# UNITED STATES PATENT AND TRADEMARK OFFICE

APPLICATION NO.	FILING DATE	FIRST NAMED INVENTOR	ATTORNEY DOCKET NO.	CONFIRMATION NO.
10/510,432	10/06/2004	Yukio Kimura	04581/LH	1515

<b>Office Action Summary</b>	<b>Application No.</b> 10/510,432	<b>Applicant(s)</b> KIMURA ET AL.	
	<b>Examiner</b> Debra Wolfe	<b>Art Unit</b> 3725

## DETAILED ACTION

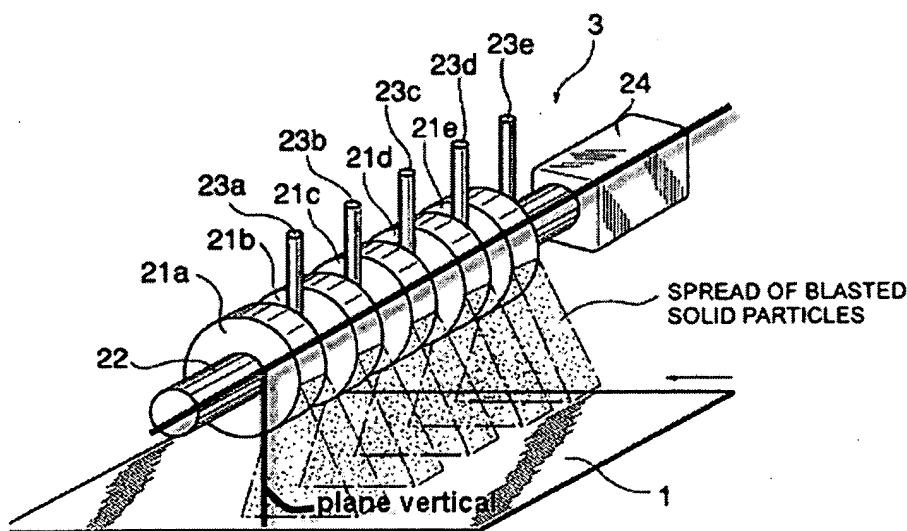
The drawings are objected to under 37 CFR 1.83(a). The drawings must show every feature of the invention specified in the claims. Therefore, a reference to "the plane vertical to the rotation axis" must be shown or the feature(s) canceled from the claim(s). No new matter should be entered.

Claims 1-9 are rejected under 35 U.S.C. 112, second paragraph, as being indefinite for failing to particularly point out and distinctly claim the subject matter which applicant regards as the invention. The limitation of claim 1 referring to the plane vertical to the rotation axis is unclear therefore rendering the claim indefinite. Applicant fails to disclose in the specification and drawings what is the plane vertical. It appears that applicant is trying to claim the orientation of the blast range with respect to the direction of travel of the metallic plate by defining the orientation of the blasting machine, however as understood by the Examiner the plane vertical to the rotation of axis is unable to be parallel but rather will be perpendicular to the direction of travel of the metallic sheet [See FIG below].
